Top Drive Model C500-681 Torque Curve Correction

Issue

Figure 1: Top Drive Model C500-681 Torque curve

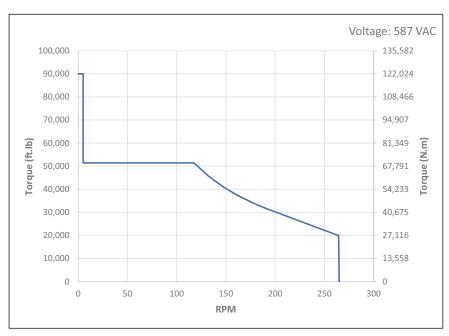
The top drive torque curve has been found to be incorrect in several product manuals for the Canrig Model C500-681 made prior to November 11, 2022. See Section 2, page 2-5.

Product manuals made for Models C500-681/1250AC-681, serial number 1411 and older.

Please see corrected torque curve below.

Top Drive Model C500-681 with GE B20 AC Motor
